DUKE POWER COMPANY

November 16, 1984

Subject: McGuire Nuclear Station
Docket Nos. 50-369 and 50-370
McGuire 2/Cycle 2 OFA Reload

Proposed McGuire Unit 1 and 2 Technical Specification Changes

FIGURE 2.1-1b

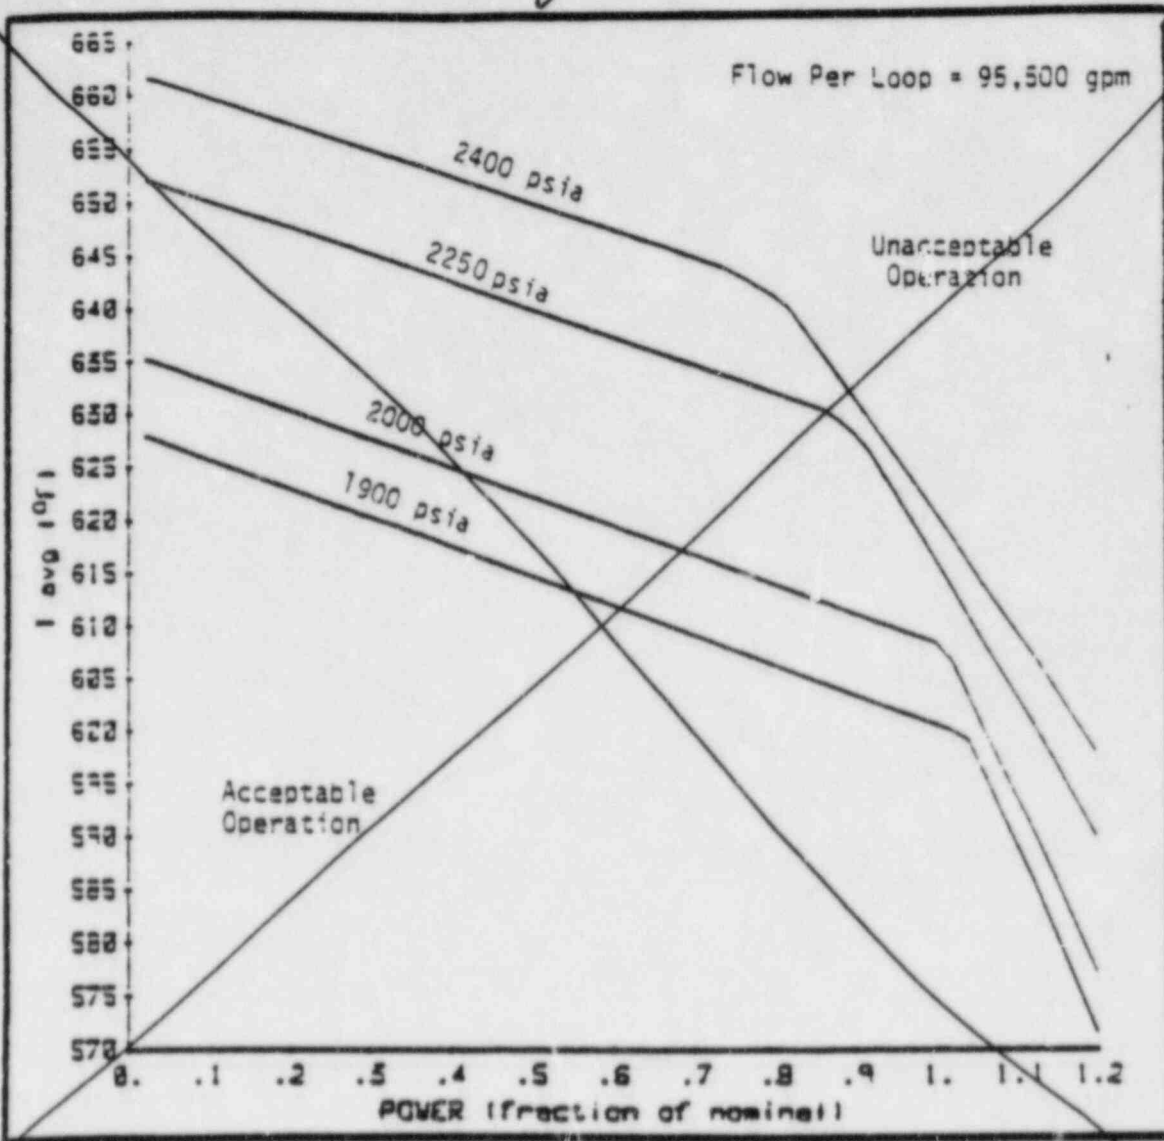
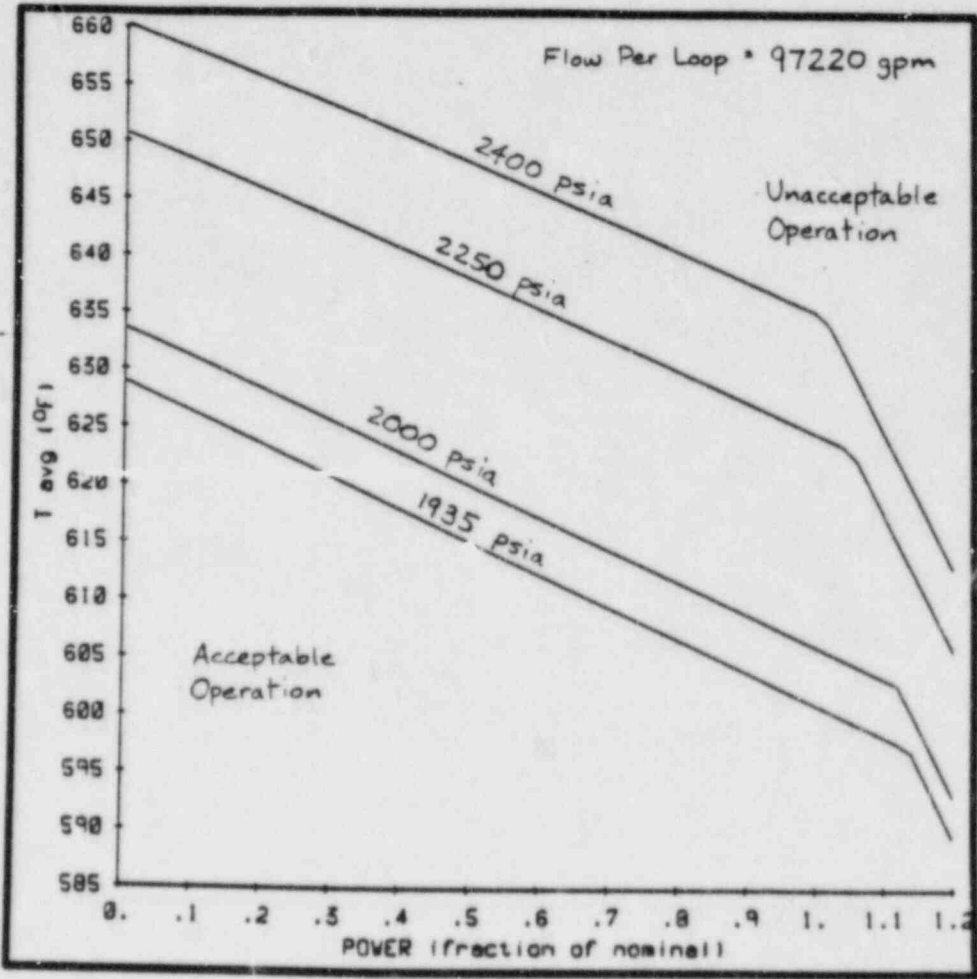
REPLACE FIG WITH THE FOLLOWING
FIGURE (X)

FIGURE 3.2-1
 AXIAL FLUX DIFFERENCE LIMITS AS A FUNCTION OF RATED THERMAL POWER ~~UNIT 1~~

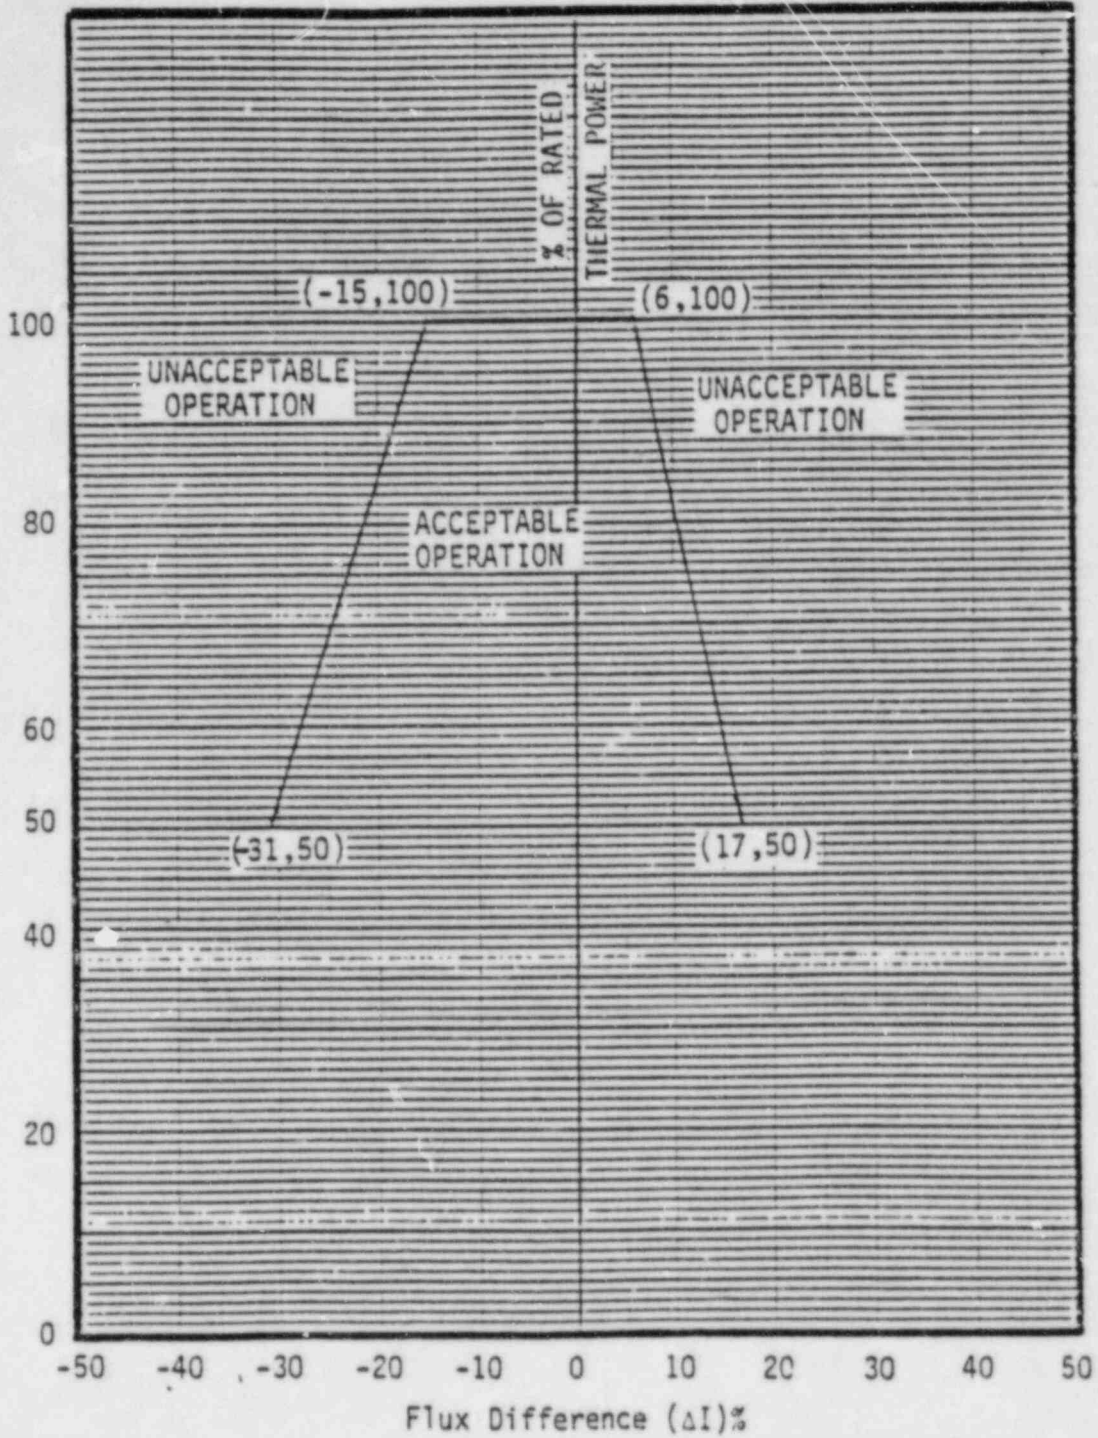
DELETE ENTIRE PAGE

FIGURE 3.2-2b
K(Z) - NORMALIZED $F_Q(Z)$ AS A FUNCTION OF CORE HEIGHT (UNIT 2)

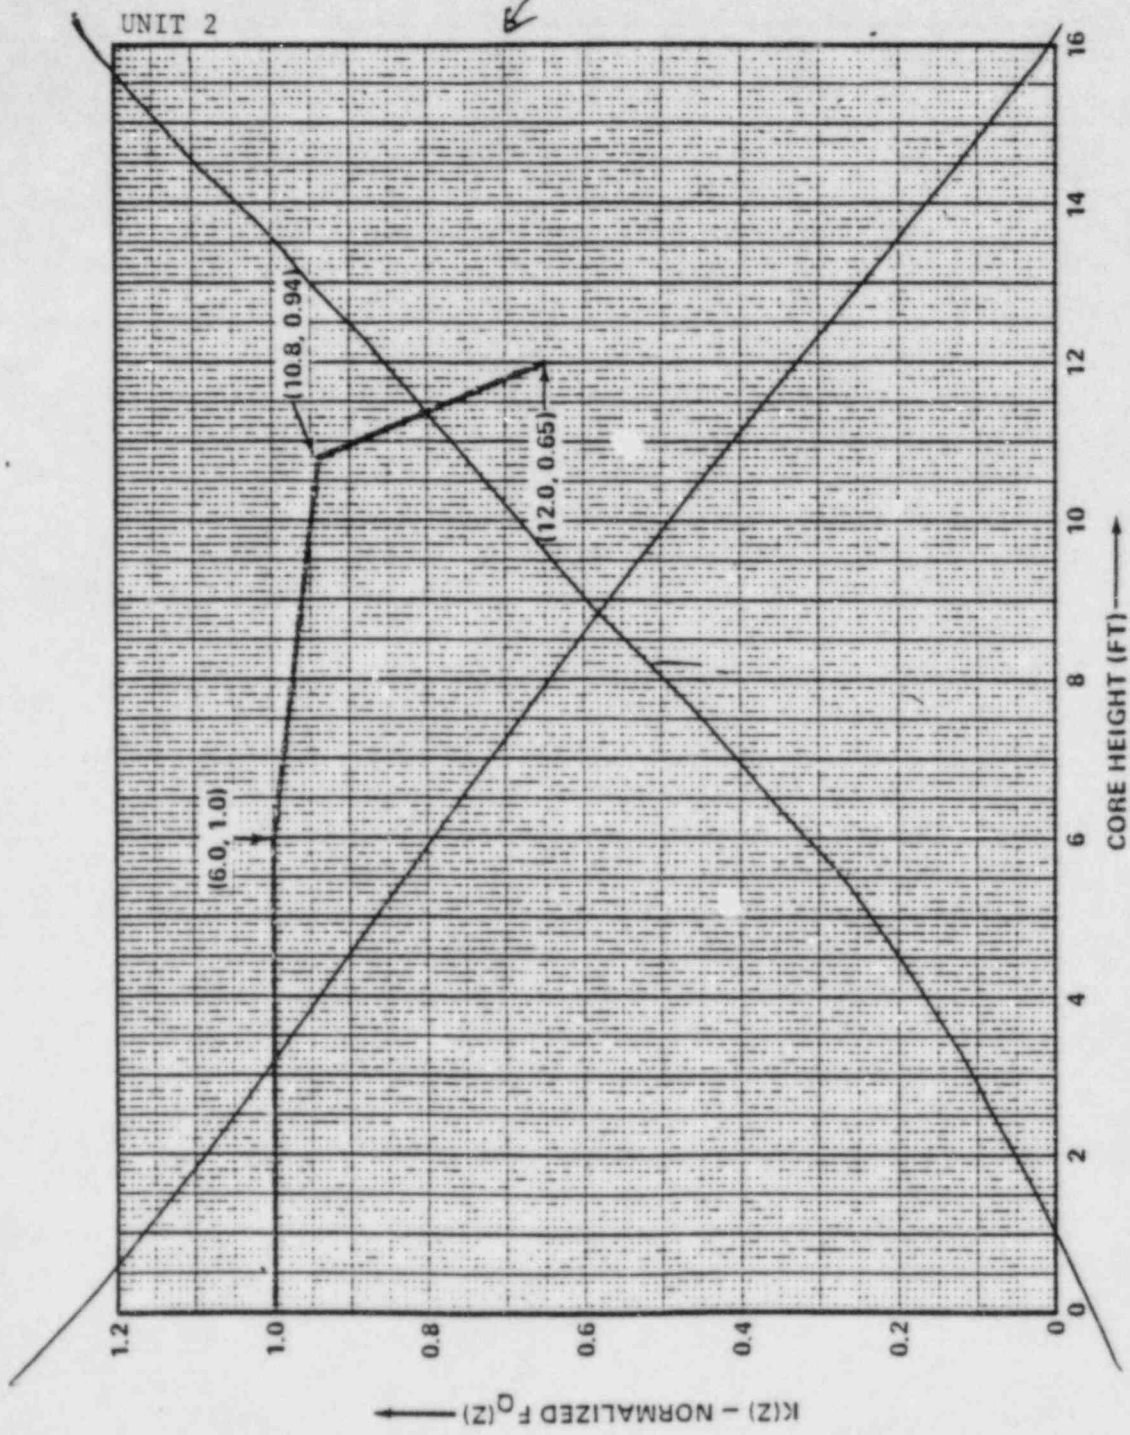
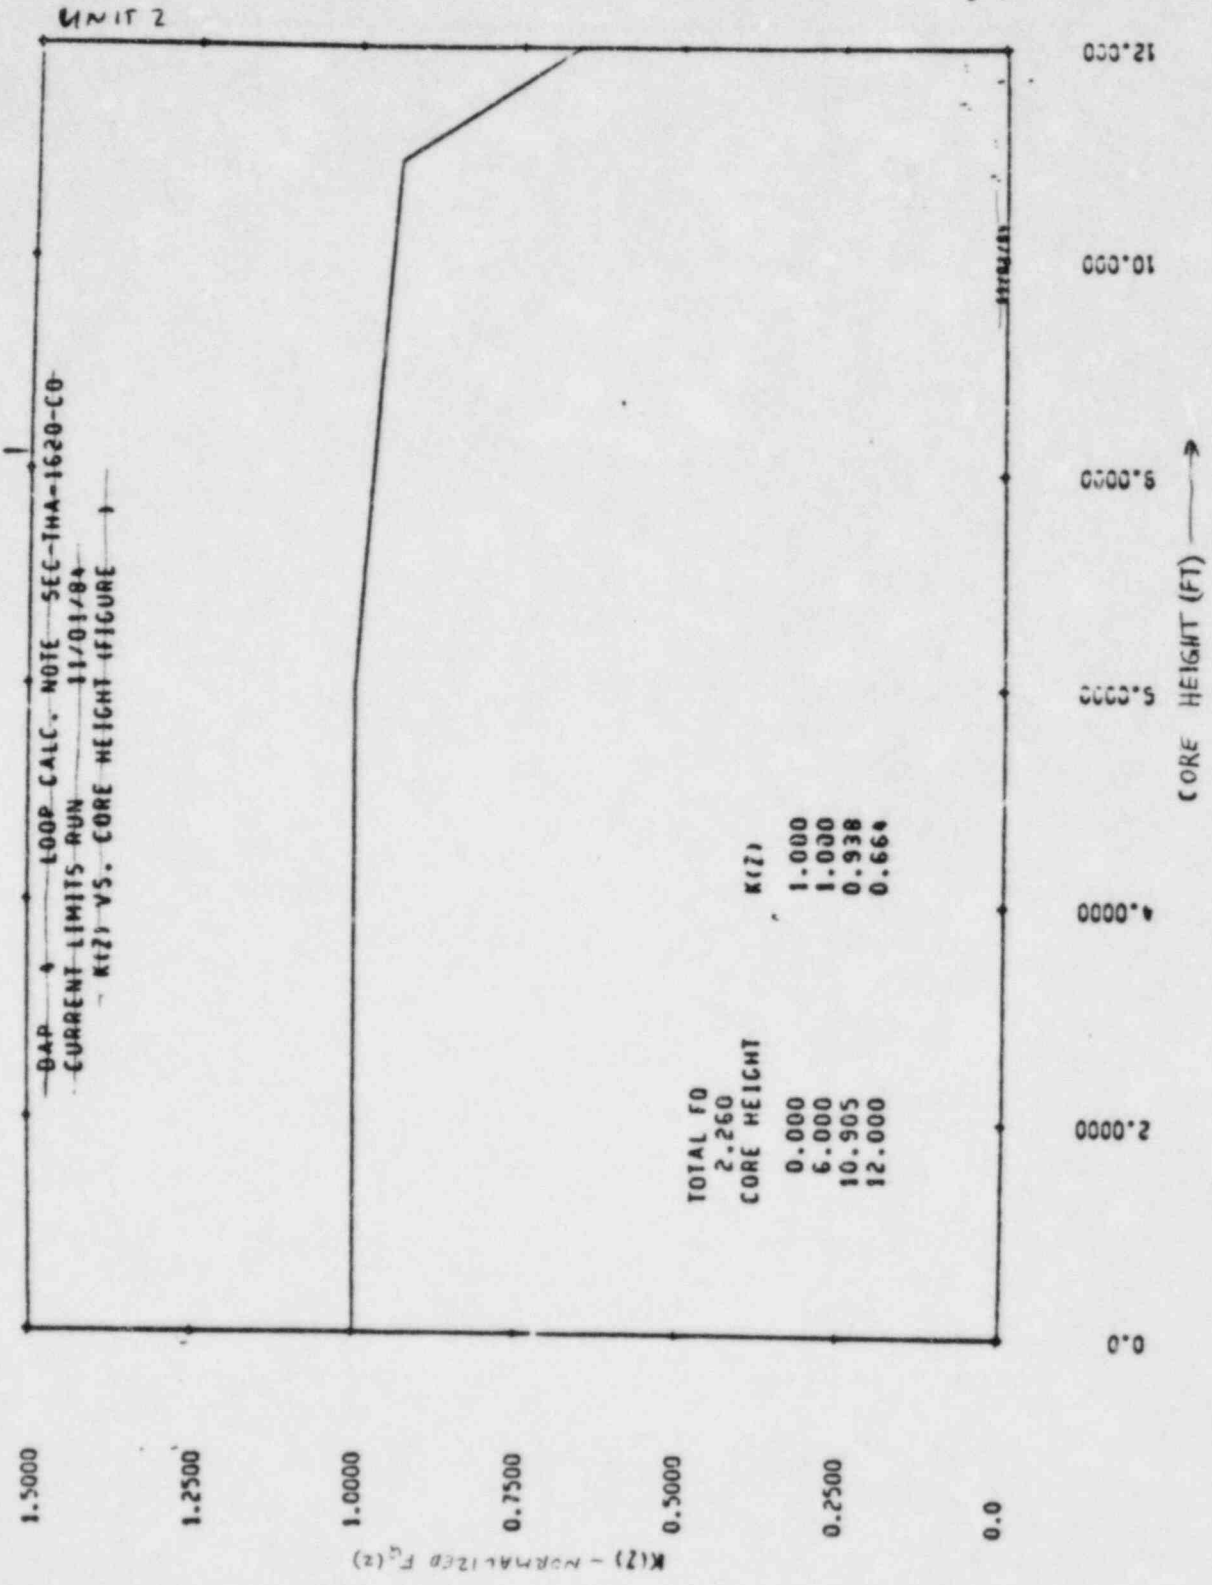
REPLACE FIG WITH THE FOLLOWING
FIGURE ②

FIGURE 3.2-4 ROD BOW PENALTY AS A FUNCTION OF BURNUP (Unit 2)

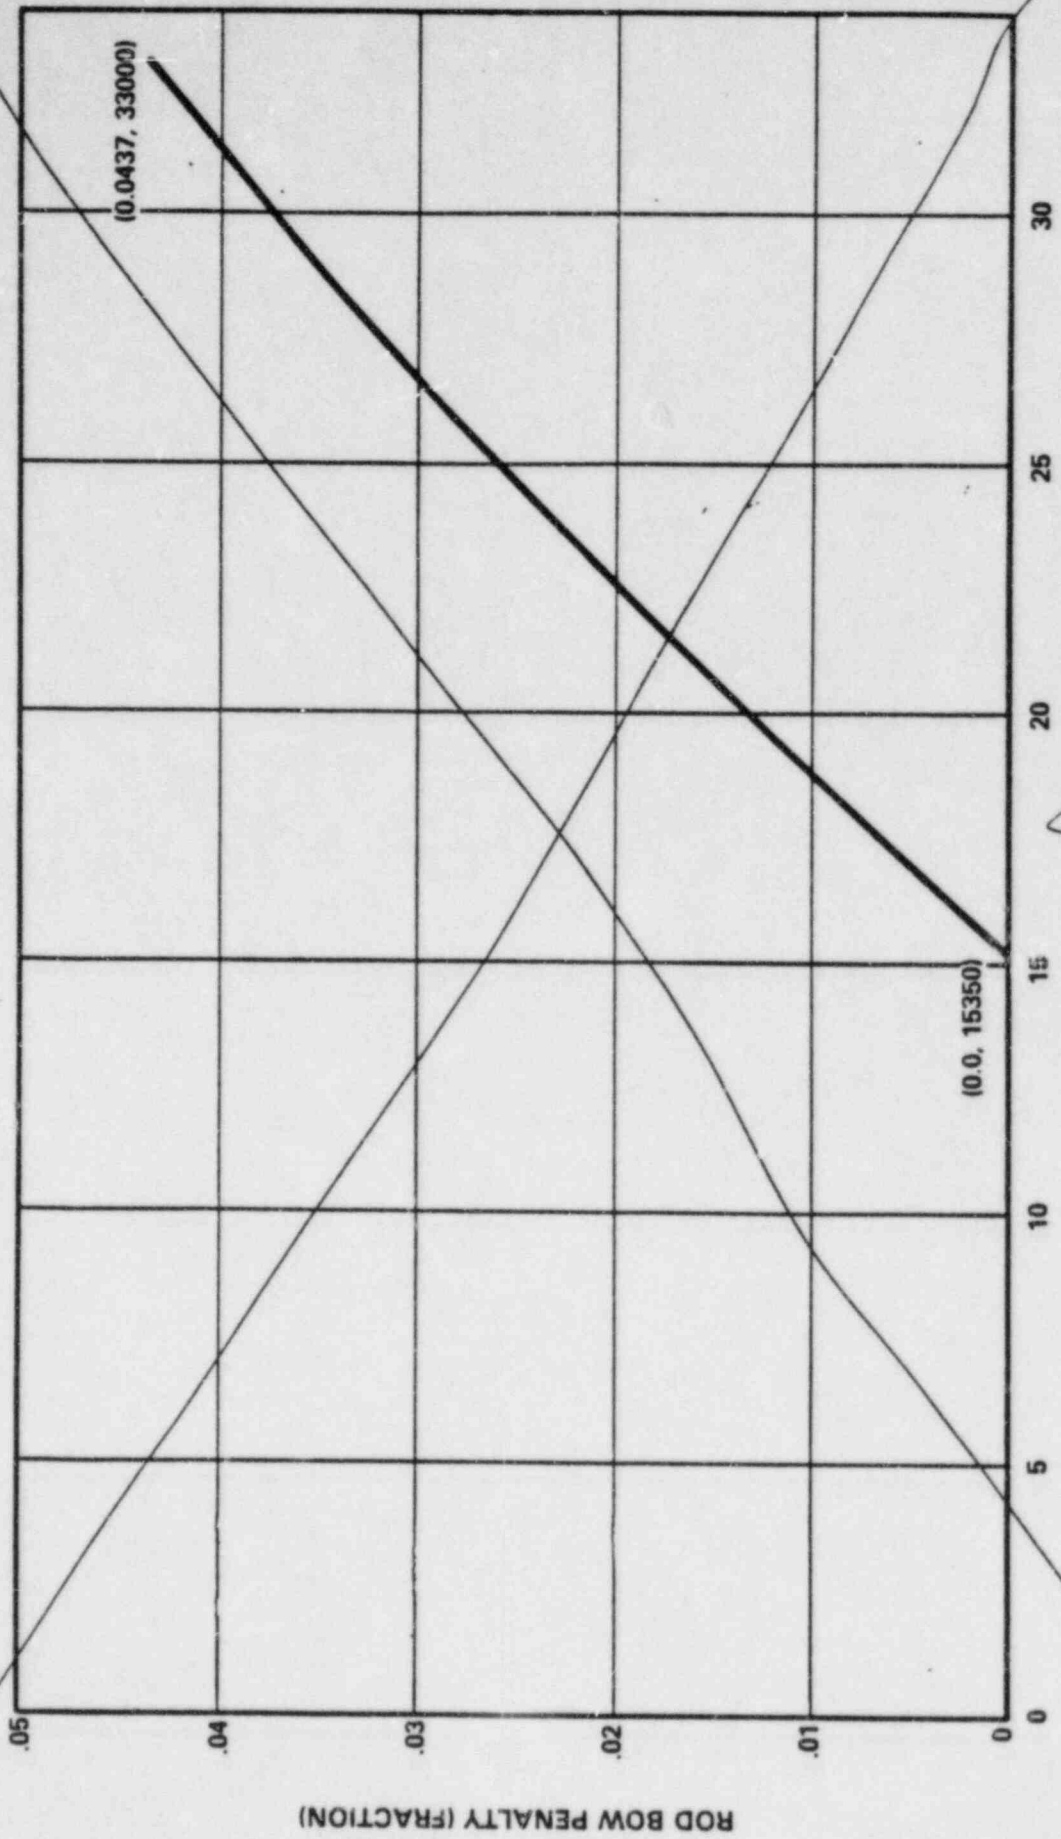
DELETE
ENTIRE
PAGE
